Project
Living Choice Galston Retirement Village Building 1
Project Number
25003 - 1
Project Stage
CC
Client
Living Choice Australia Pty Ltd
Drawing Title
SITE PLAN

MINOR CHANGES WITH NIL IMPACT TO
NEIGHBOURS

Project
Living Choice Galston Retirement Village Building 2

Project Number 25003 - 2	Project Stage CC	Client Living Choice Australia Pty Ltd
Drawing Title BASEMENT FLOOR PLAN

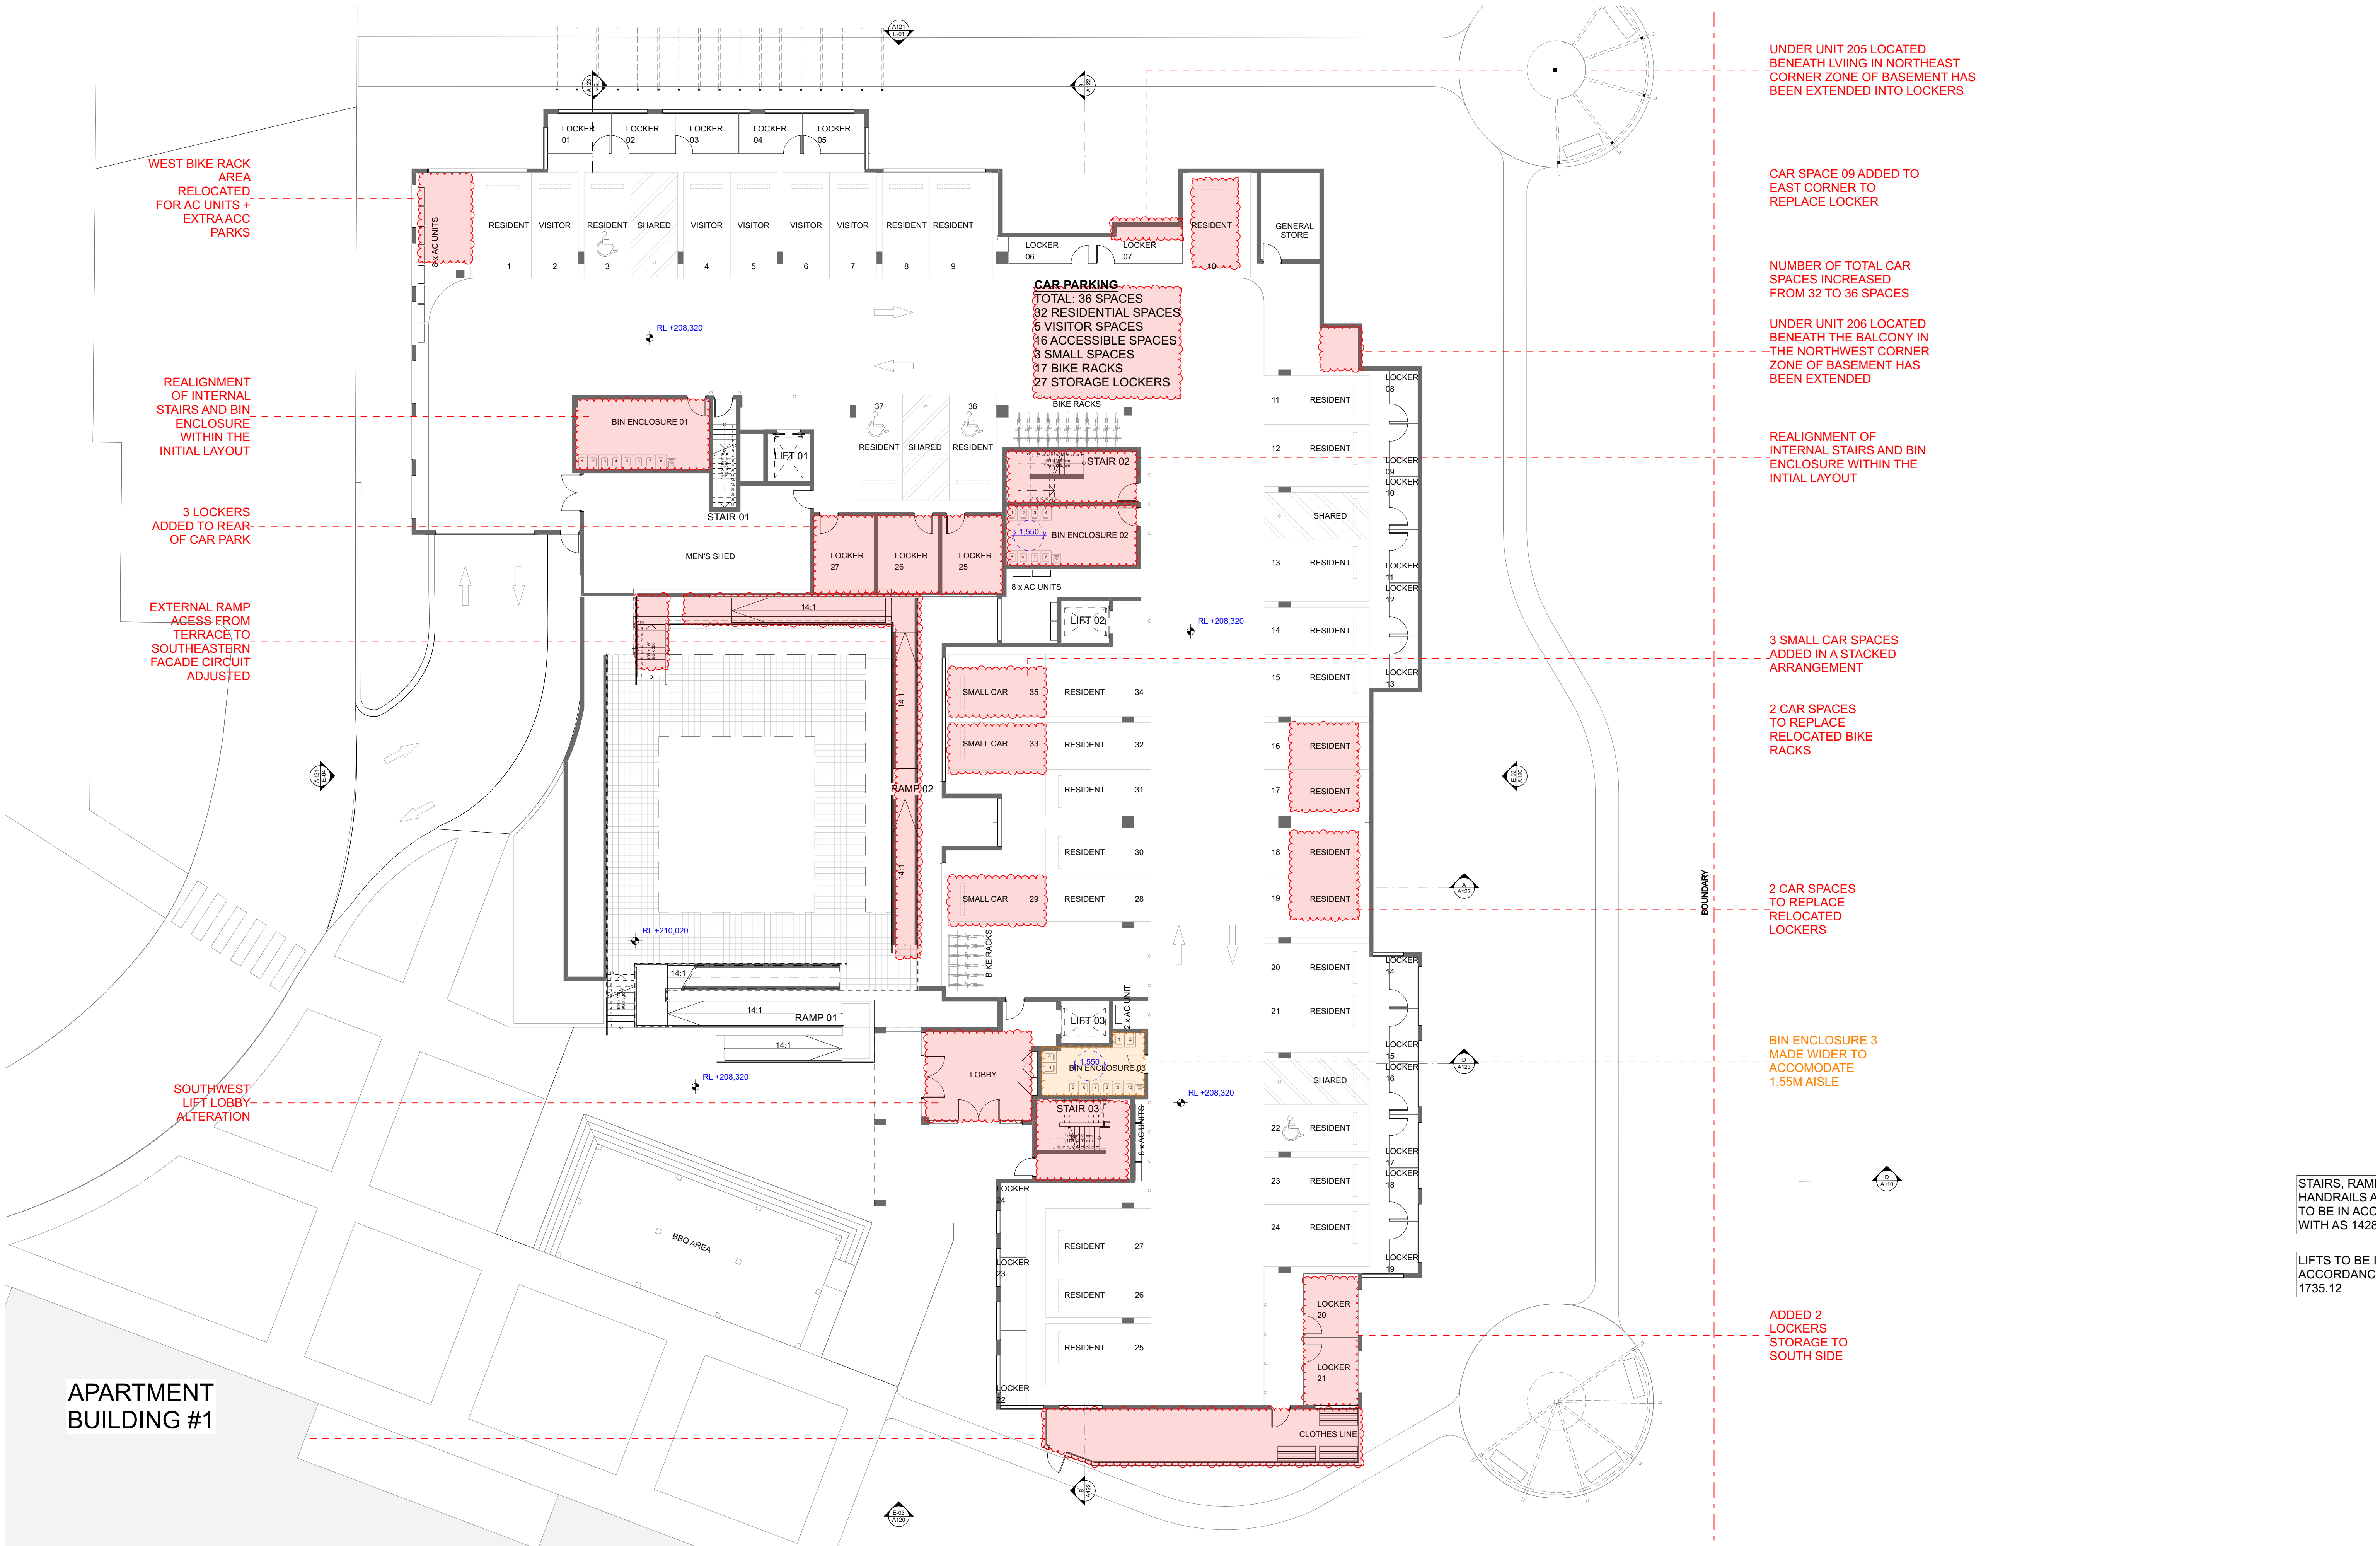
UNDER UNIT 205 LOCATED
BENEATH LIVING IN NORTHEAST
CORNER ZONE OF BASEMENT HAS
BEEN EXTENDED INTO LOCKERS

CAR SPACE 09 ADDED TO
EAST CORNER TO
REPLACE LOCKER

NUMBER OF TOTAL CAR
SPACES INCREASED
FROM 32 TO 36 SPACES

UNDER UNIT 206 LOCATED
BENEATH THE BALCONY IN
THE NORTHWEST CORNER
ZONE OF BASEMENT HAS
BEEN EXTENDED

REALIGNMENT OF
INTERNAL STAIRS AND BIN
ENCLOSURE WITHIN THE
INITIAL LAYOUT

3 SMALL CAR SPACES
ADDED IN A STACKED
ARRANGEMENT

2 CAR SPACES
TO REPLACE
RELOCATED BIKE
RACKS

2 CAR SPACES
TO REPLACE
RELOCATED
LOCKERS

BIN ENCLOSURE 3
MADE WIDER TO
ACCOMMODATE
1.55M AISLE

ADDED 2
LOCKERS
STORAGE TO
SOUTH SIDE

Project
Living Choice Galston Retirement Village Building 2
Project Number
25003 - 2
Project Stage
CC
Client
Living Choice Australia Pty Ltd
Drawing Title
GROUND FLOOR PLAN

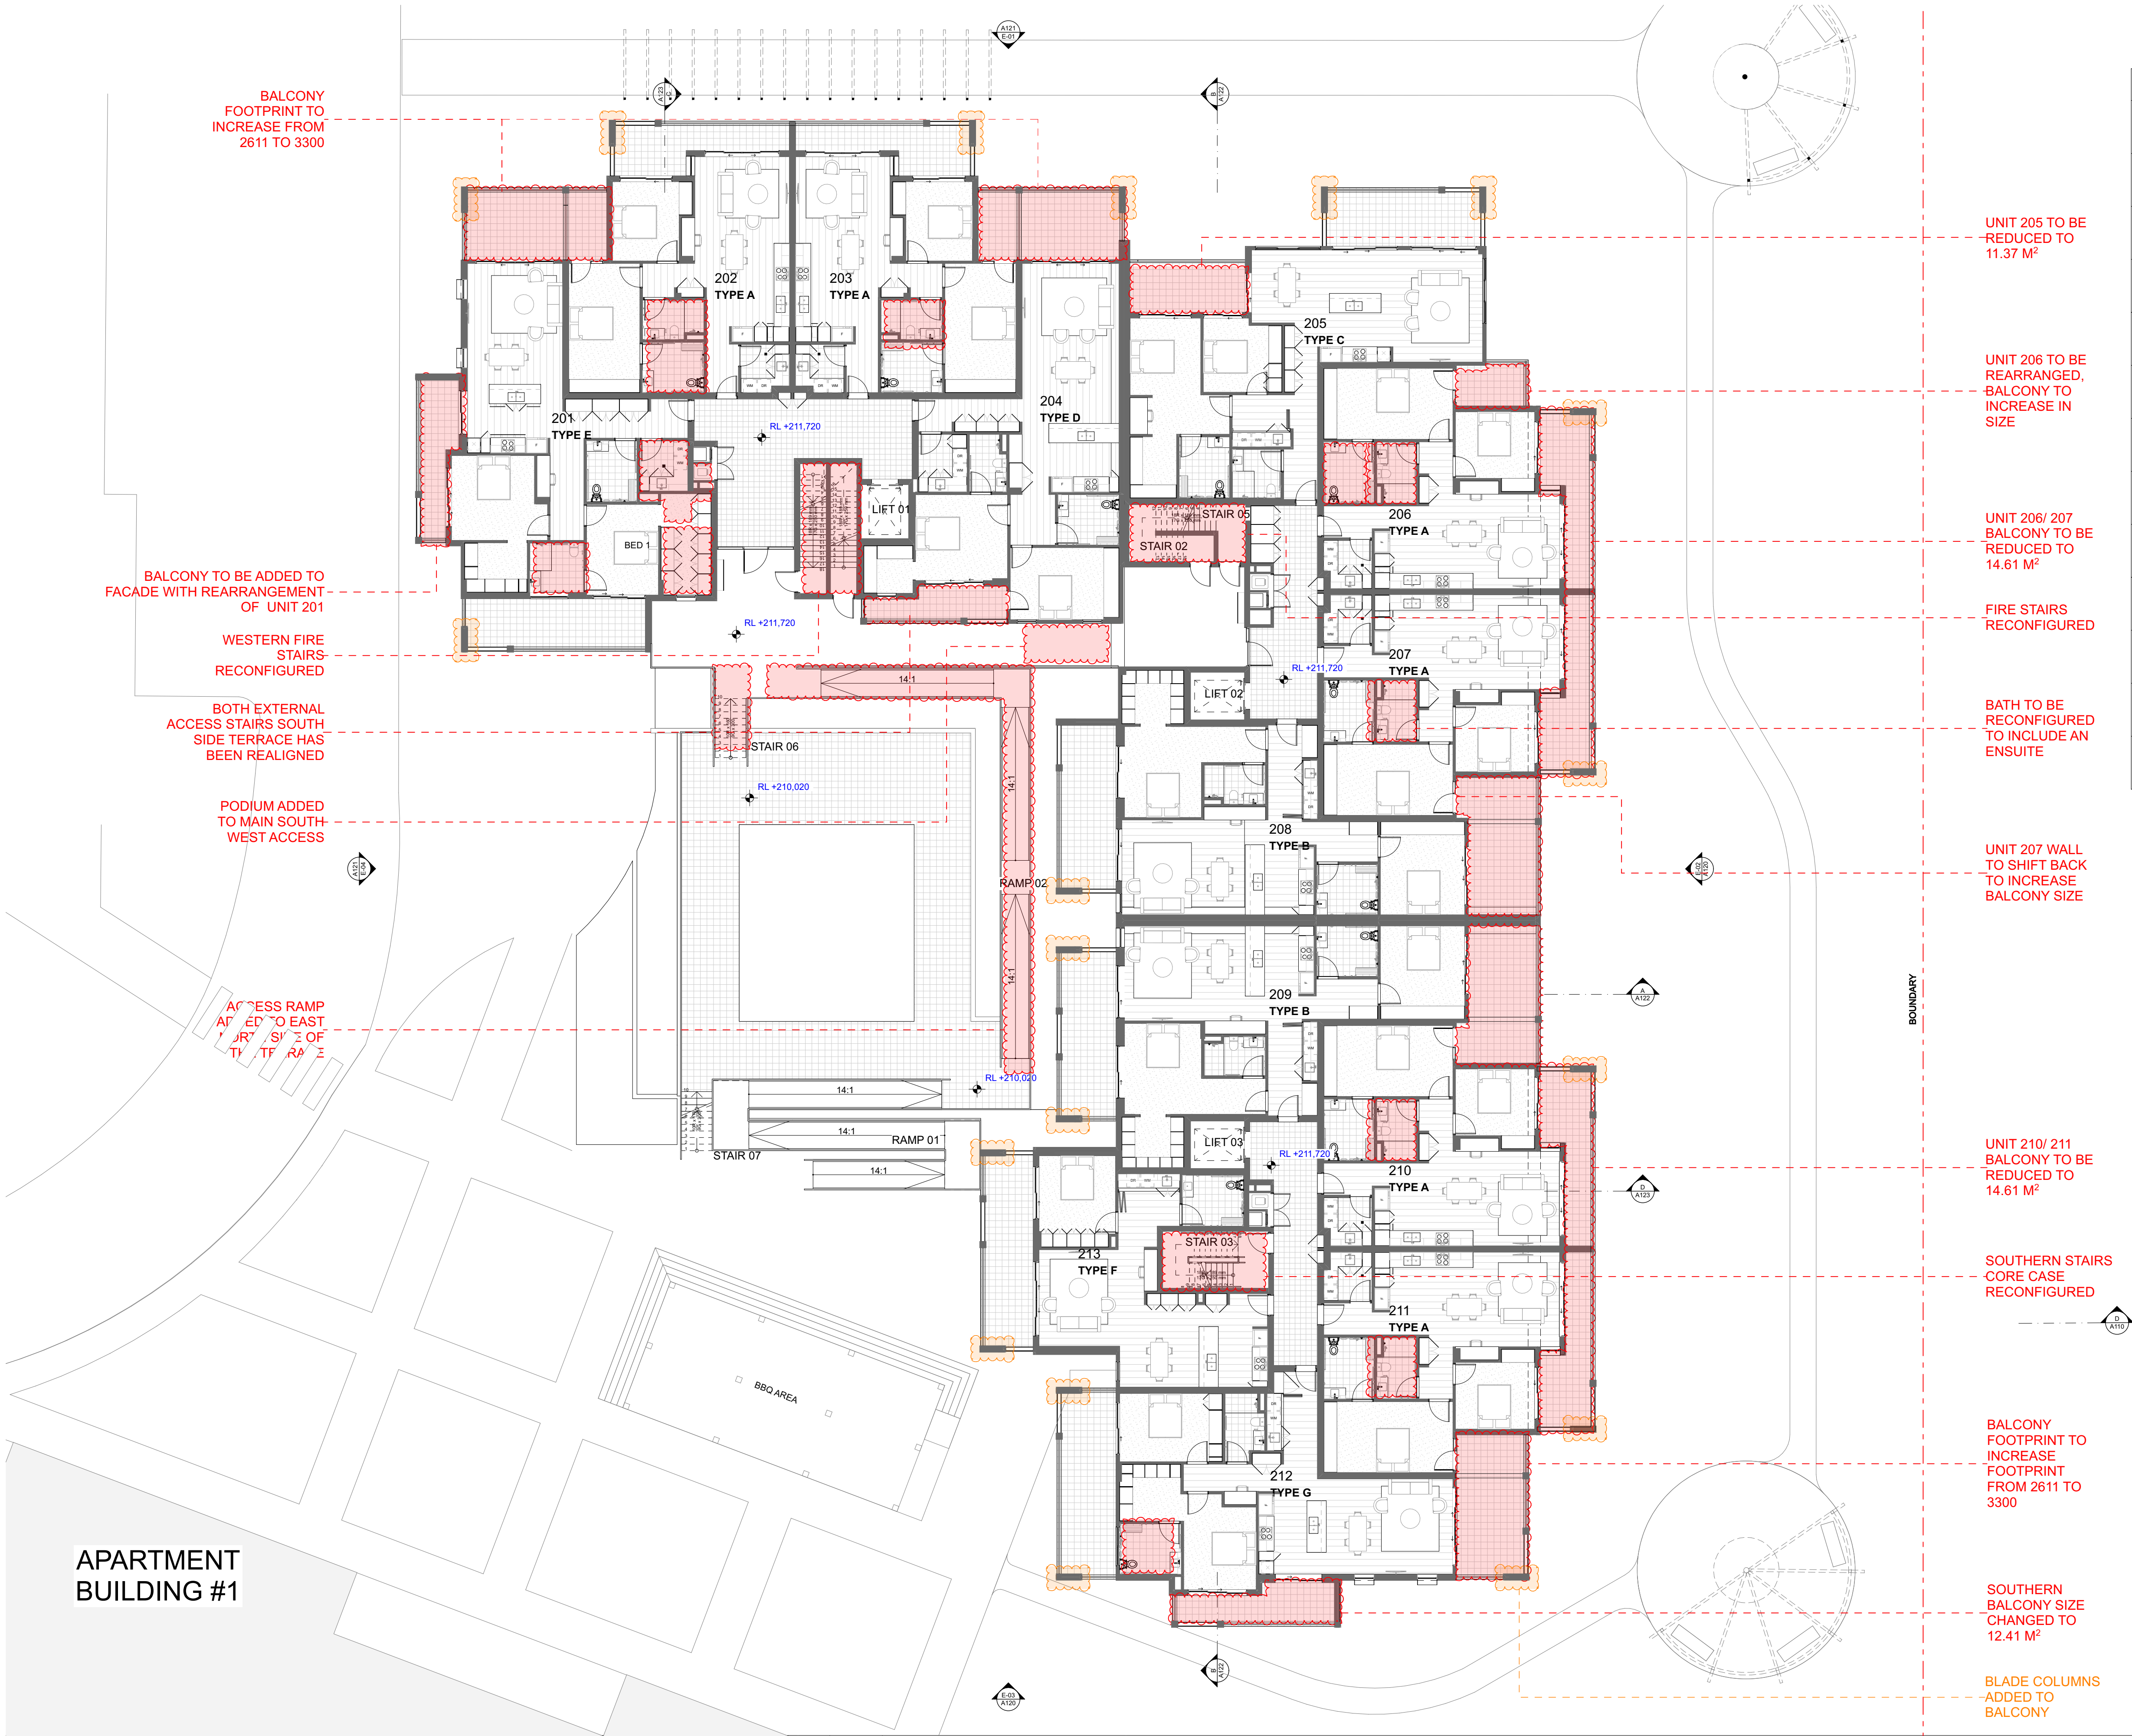
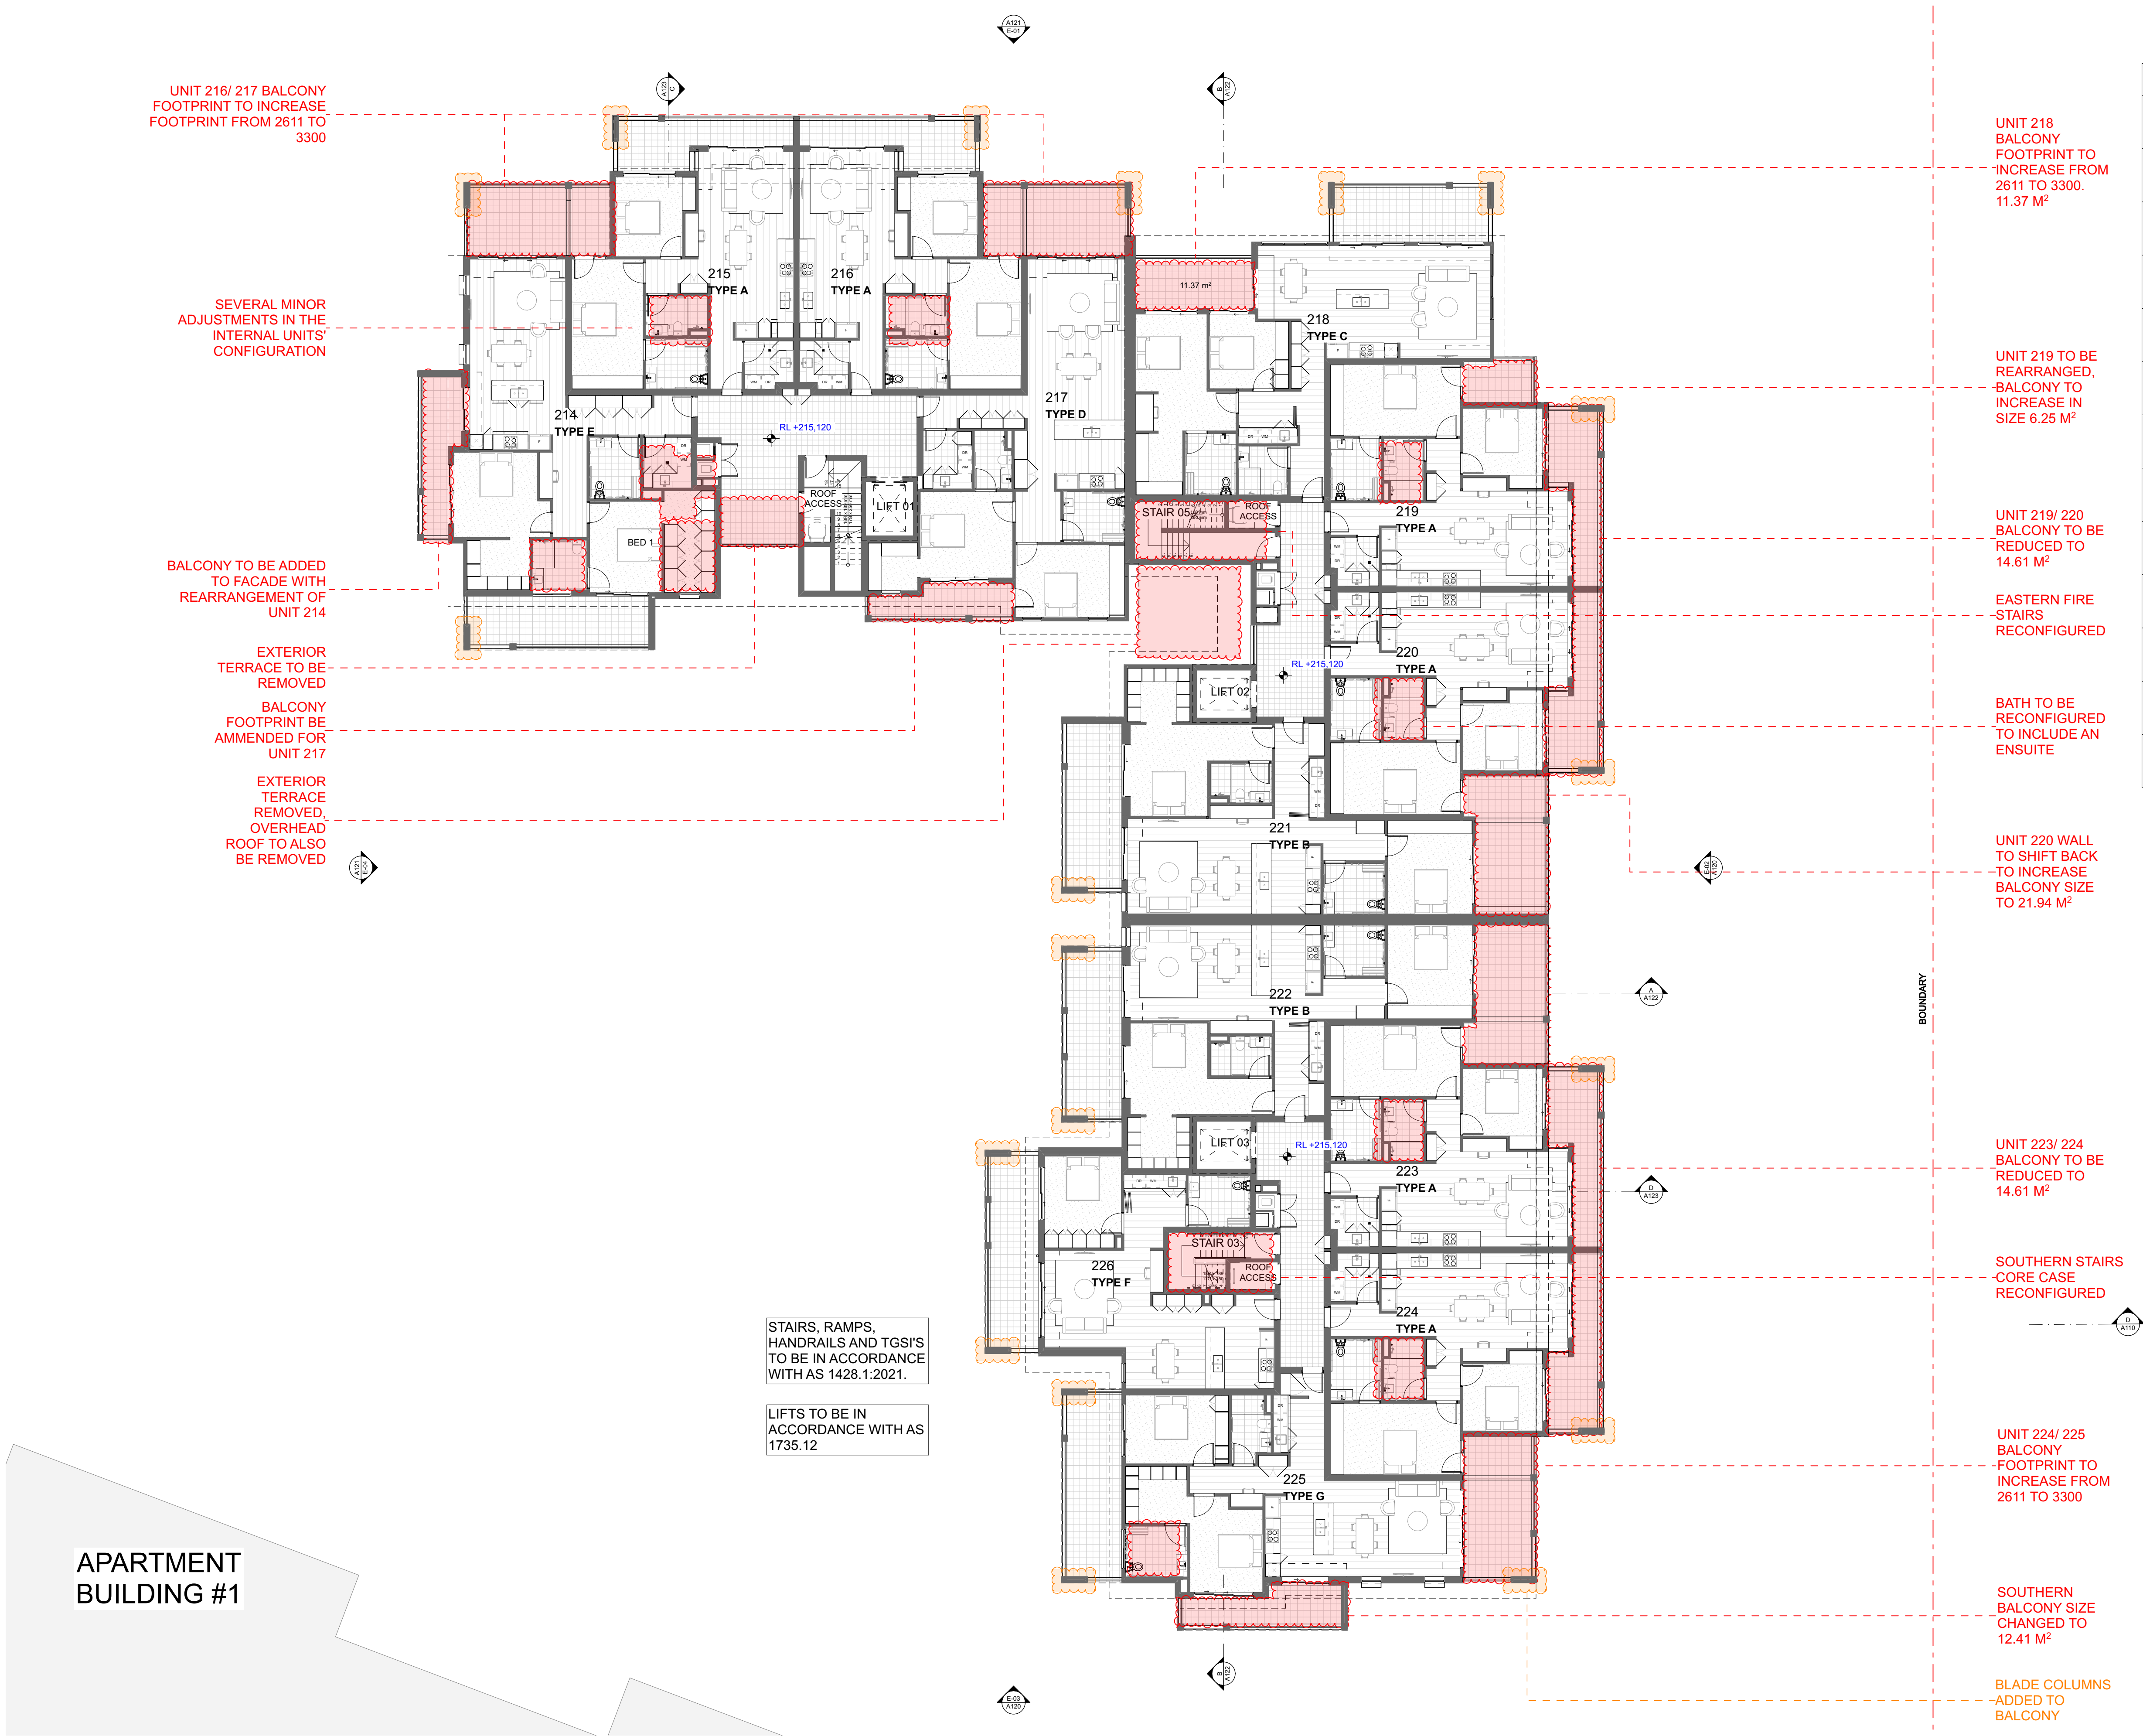
UNIT 205 TO BE
REDUCED TO
11.37 M²

UNIT 206 TO BE
REARRANGED,
BALCONY TO
INCREASE IN
SIZE

UNIT 206/ 207
BALCONY TO BE
REDUCED TO
14.61 M²

FIRE STAIRS
RECONFIGURED

BATH TO BE
RECONFIGURED
TO INCLUDE AN
ENSUITE

UNIT 207 WALL
TO SHIFT BACK
TO INCREASE
BALCONY SIZE

UNIT 210/ 211
BALCONY TO BE
REDUCED TO
14.61 M²

SOUTHERN STAIRS
CORE CASE
RECONFIGURED

BALCONY
FOOTPRINT TO
INCREASE
FOOTPRINT
FROM 2611 TO
3300

SOUTHERN
BALCONY SIZE
CHANGED TO
12.41 M²

BLADE COLUMNS
ADDED TO
BALCONY
